October 11, 2017
GZA File No. 03.0033554.60-C

Re: Short Term Response Action Plan (STRAP) Addendum
Proposed Liquefaction Facility
121 Terminal Road
RIDEM File No. SR-28-1152
RIDEM Case Number: 98-004
Providence, Rhode Island

GZA GeoEnvironmental, Inc. (GZA), on behalf of National Grid LNG LLC (NGLNG), has prepared this *Short Term Response Action Plan (STRAP) Addendum* for the Proposed Liquefaction Project located in Providence, Rhode Island (herein referred to as the Site). GZA prepared and submitted a *STRAP* to RIDEM for the Proposed Liquefaction Project on May 12, 2017 (referred to herein as the May 2017 *STRAP*). This addendum serves as our response to your *STRAP Comment Letter* dated October 6, 2017. For your convenience, each of the Department's comments are repeated below followed by our responses in italics.

FIGURE 6, PROPOSED FINAL CONDITIONS PLAN (FROM THE MAY 2017 STRAP)

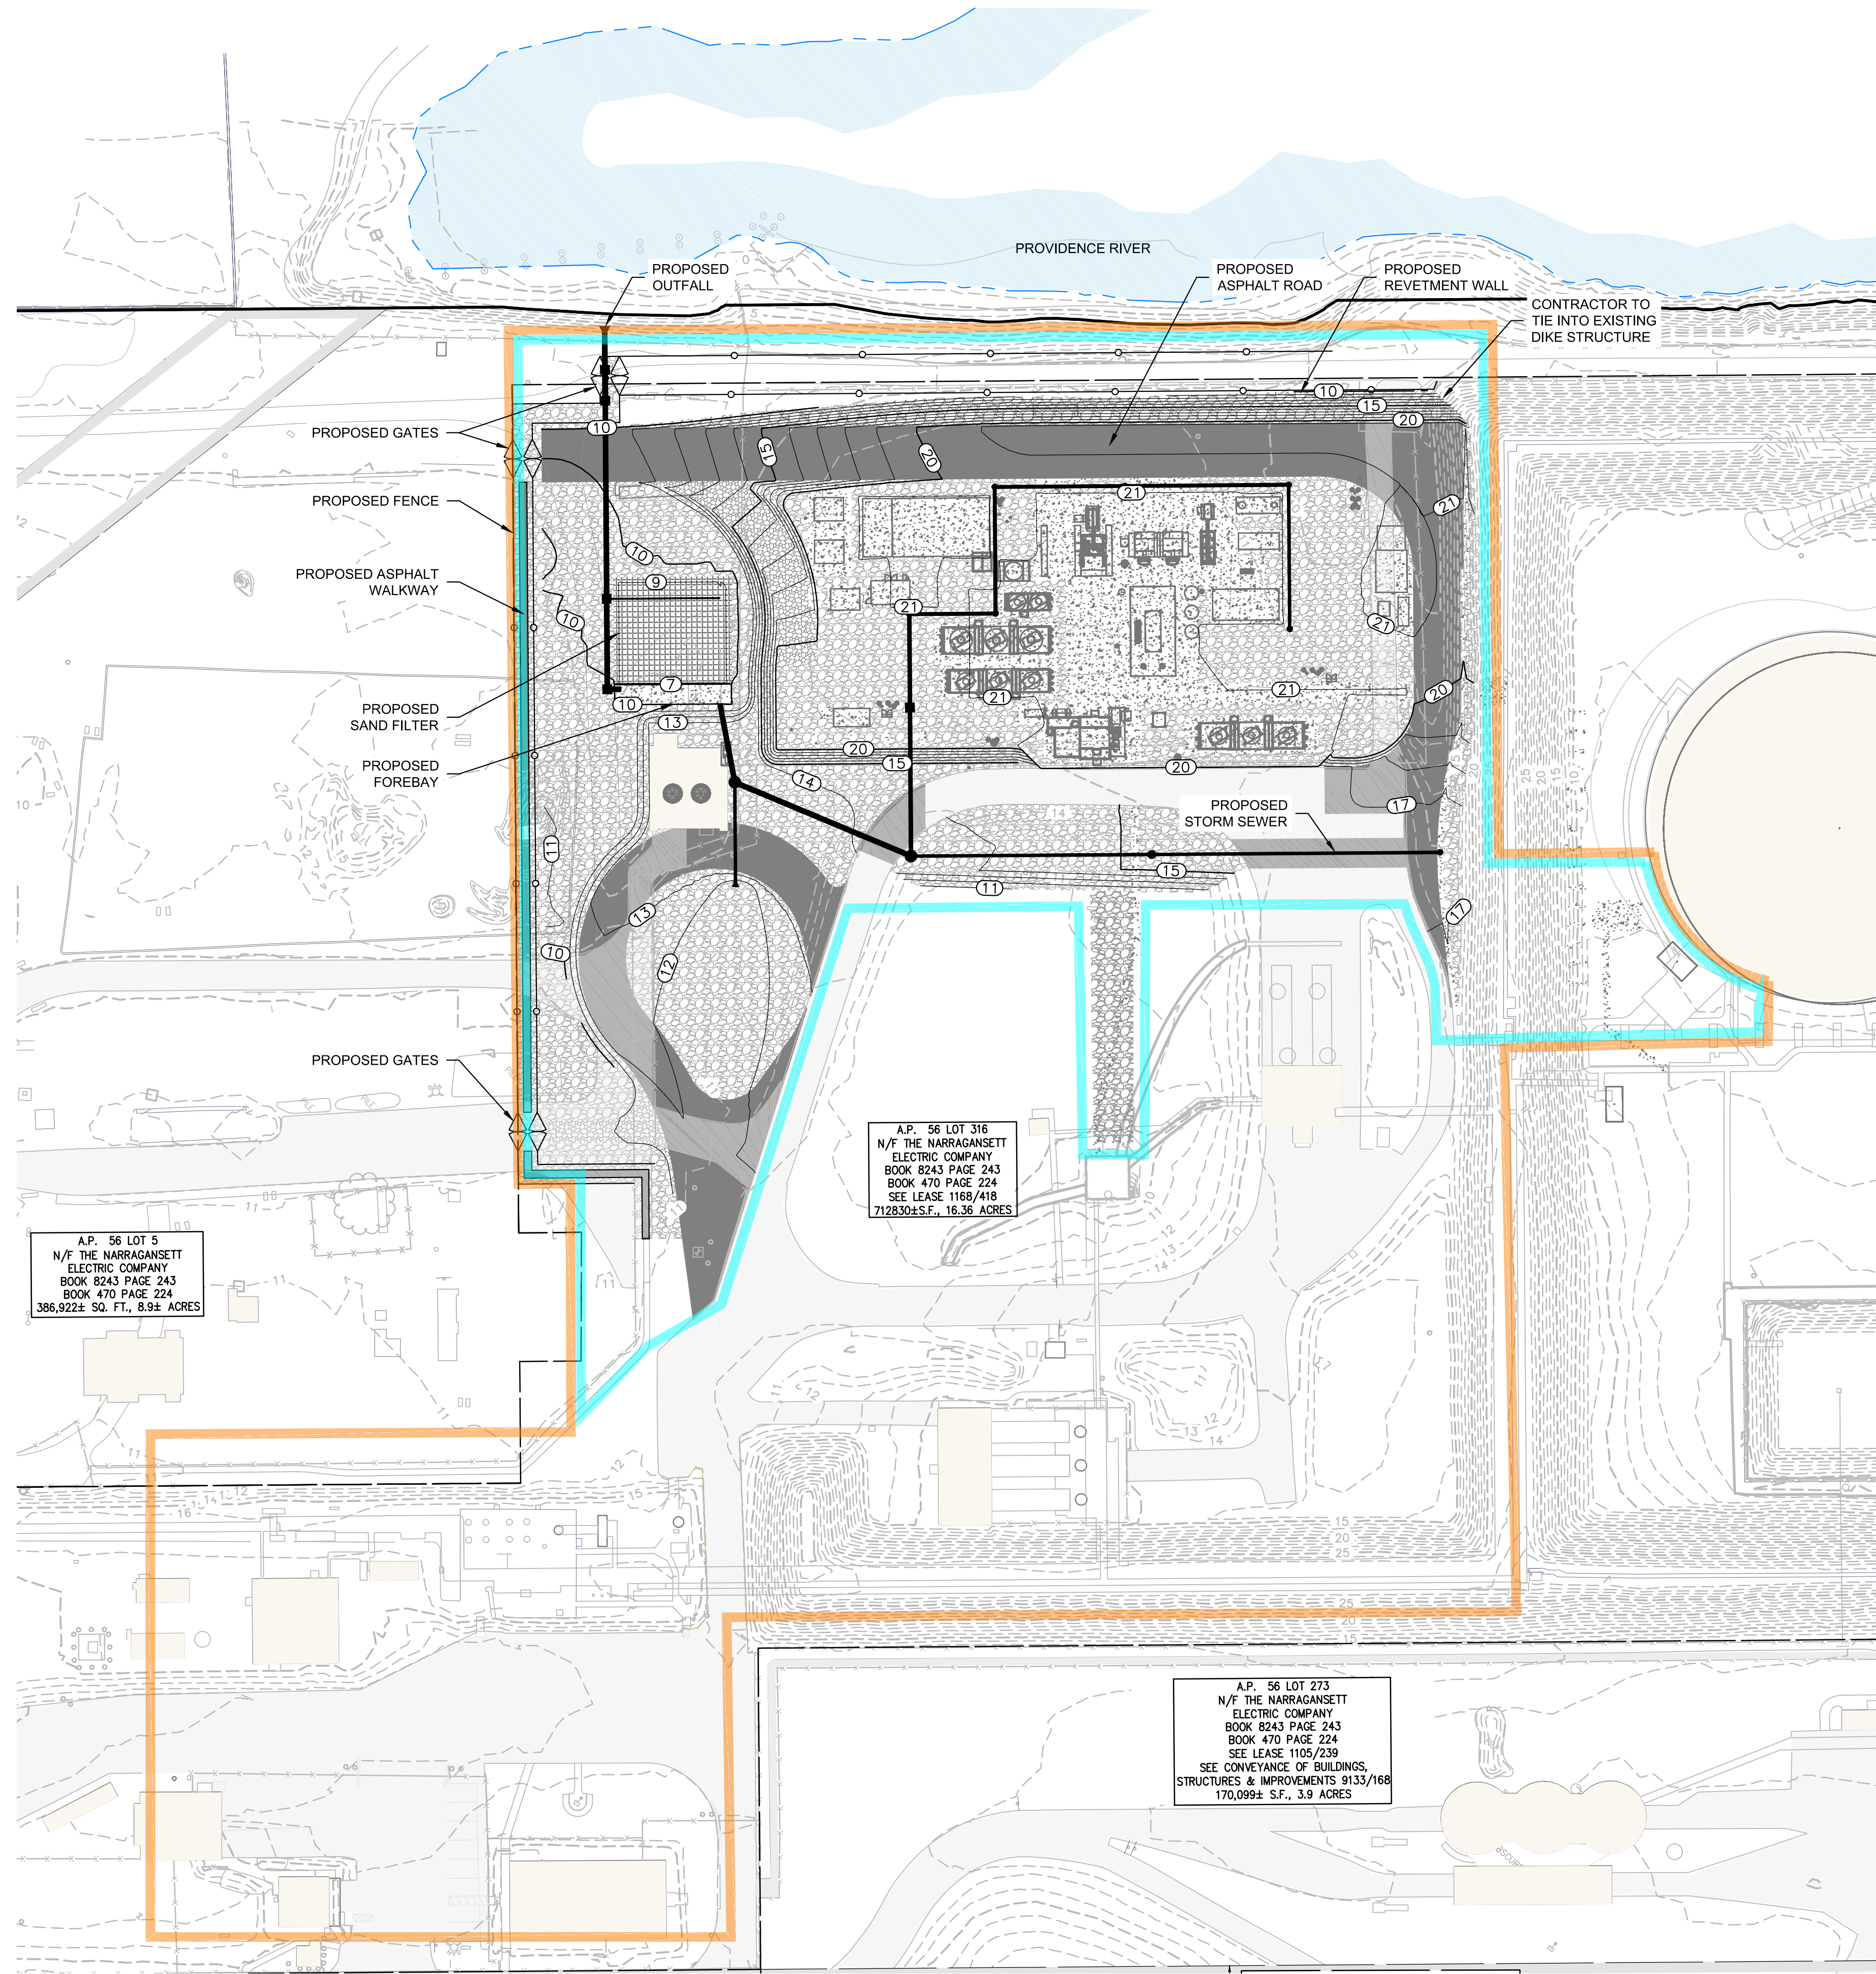
Page 4, Section 3.1 (Project Description), Please clarify the planned order of proposed remedial events, including raising the level of the STRAP Area, pre-drilling/driving piles, installing underground utilities, removing existing groundwater monitoring wells, reinstalling replacement monitoring wells, installing engineered caps and implementing related restoration activities, etc.

Regarding Drawing 4 (Completed Remedial Activities) and Drawing 6 (Proposed Final Conditions Plan), please clarify plans for areas within the proposed Project Work Site that have not been subject to prior remediation and capping, and do not currently have an existing equivalent cap, but are not identified on Drawing 6 as being subject to proposed capping. Please be advised that any unremediated areas on the Site, that are not subject to remedial activities under the Liquefaction STRAP, shall be subject to remediation under the anticipated Site Investigation Report (SIR) Addendum for the remainder of the Site.

The proposed liquefaction project schematic is illustrated on Figure 6, Proposed Final Conditions Plan. These figures, which were included in the May 2017 STRAP, are attached for reference.

Acknowledged. All areas disturbed by the proposed STRAP activities will be restored with a RIDEM-approved engineered cap consistent with those presented in the May 2017 STRAP. Areas within the Project Work Site which do not have an existing equivalent cap and are not identified on Drawing 6 as being subject to proposed capping will be subject to remediation under the future SIR Addendum for the remainder of the Site.

FIGURE 1A, LAYDOWN PLAN

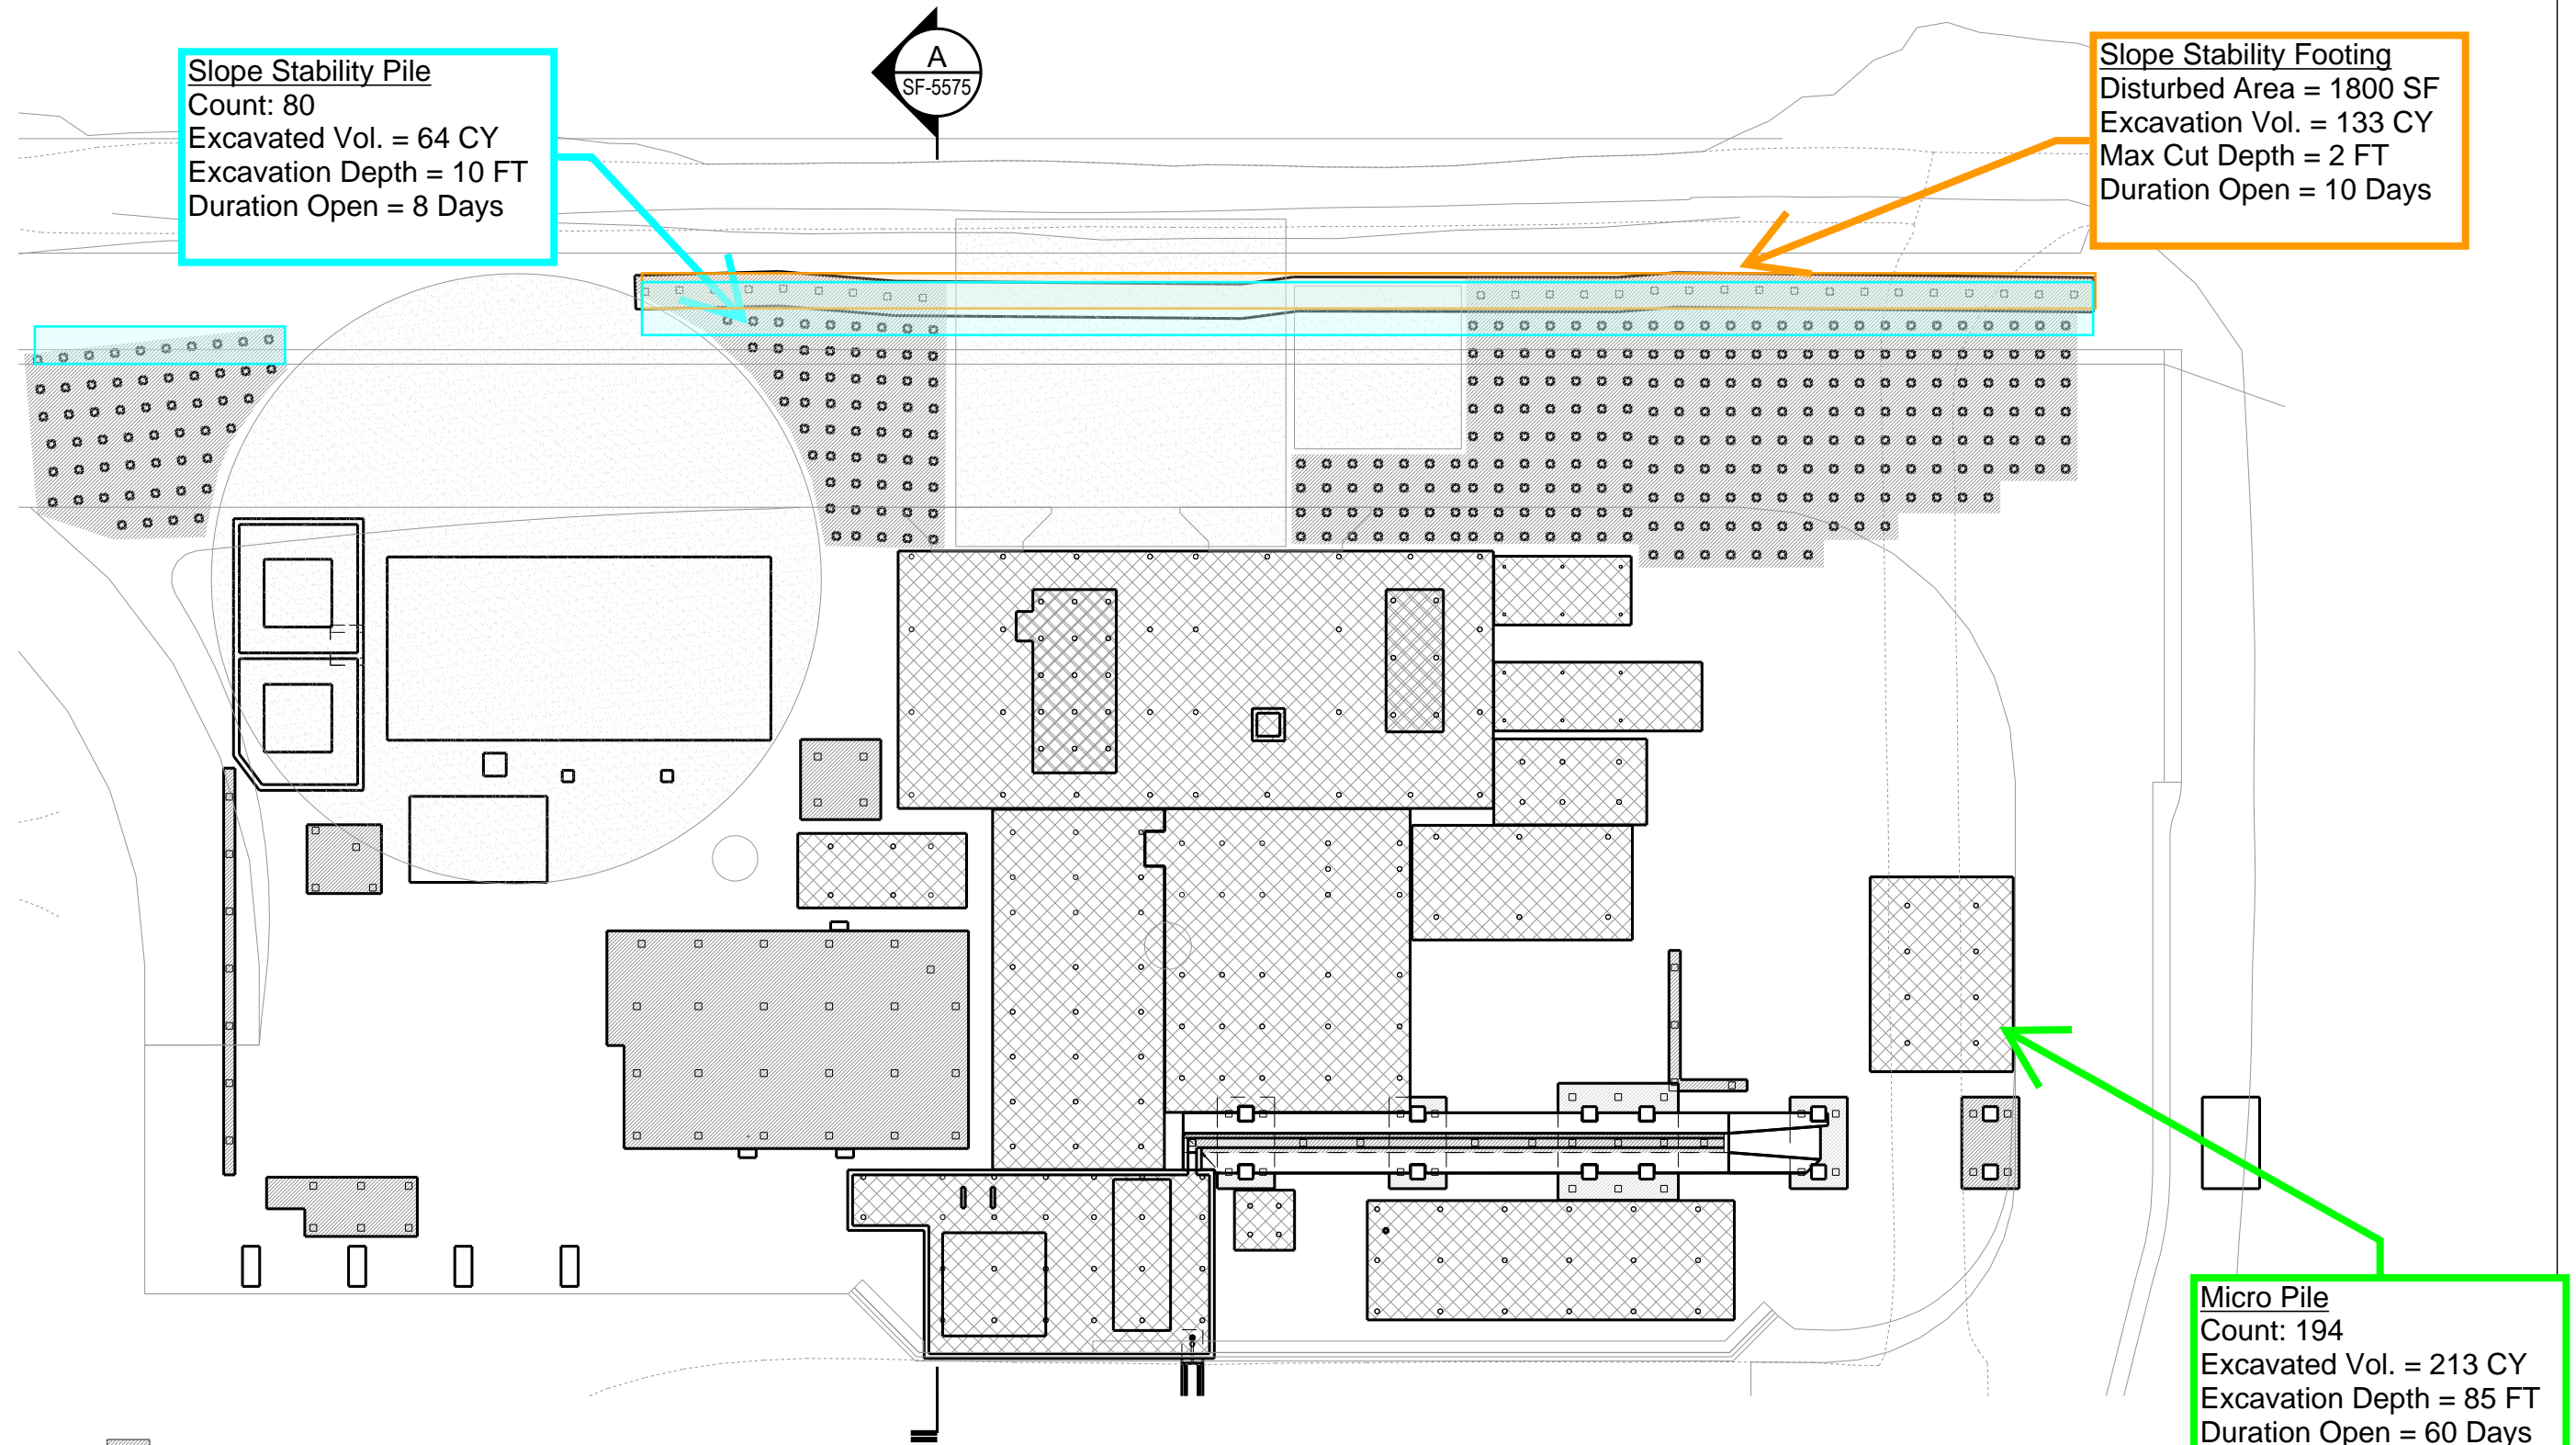
Page 4, Section 3.1 (Project Description), What are the planned dimensions of the temporary laydown area?

Page 4, Section 3.1 (Project Description), Will any regulated materials be stored in the temporary laydown area, and if so, how?

Page 4, Section 3.1 (Project Description), Please provide a site figure showing the proposed location and layout of the temporary laydown area.

Page 16, Section 6.8 (Soil Stockpile Management Requirements) - Please provide a site figure showing the proposed locations of the temporary soil stockpile area, the central soil stockpile area, and the long-term soil, construction

The laydown area is located to the west of the Project Work Site and covers approximately 6.2 acres. This proposed laydown area is illustrated on the attached Figure 1A, Laydown Plan.

Yes, regulated materials (soil and groundwater) will be stored in the Laydown Area. The proposed location for the regulated material storage is presented on the attached Figure 1A with a call out "Soil and Groundwater Management Area".

This proposed laydown area is illustrated on the attached Figure 1A, Laydown Plan.

Please see response to Comment No. 1d above. Temporary stockpiles will be staged on two layers of minimum 6-mil polyethylene sheeting or in water-tight containers directly proximate to the excavation area. At the end of each work day and to the extent practical during the workdays, working stockpiles and drilling spoils will be relocated to a central stockpile area and managed consistent with the response to Comment No.1d above. All other stockpiles (including the central stockpile area, long term, construction material and/or debris stockpiles) will be located in the soil and groundwater management area described above in the response to Comment No.1d and shown on the attached Figure 1A, Laydown Plan.

Figure N1 Air Monitoring Plan – Perimeter Locations

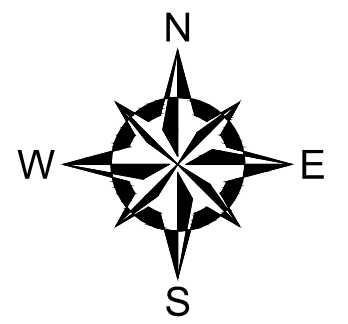
Page 15, Section 6.6 (Required Air Monitoring and Controls) - Please include a copy of Attachment N, Clarification to the Proposed Air Monitoring Program for STRAP Activities, STRAP Proposed Liquefaction Project, 121 Terminal Road/642 Allens Avenue, Providence, Rhode Island, from the October 5, 2017, Response to Public Comments, in the final STRAP Addendum.

The following table presents the real-time monitoring action levels for the STRAP perimeter locations. Figure N1 shows approximate perimeter locations that will be monitored during the earthwork. Note, as shown on Figure N1, these monitoring locations are conservatively situated proximate to the STRAP area perimeter.
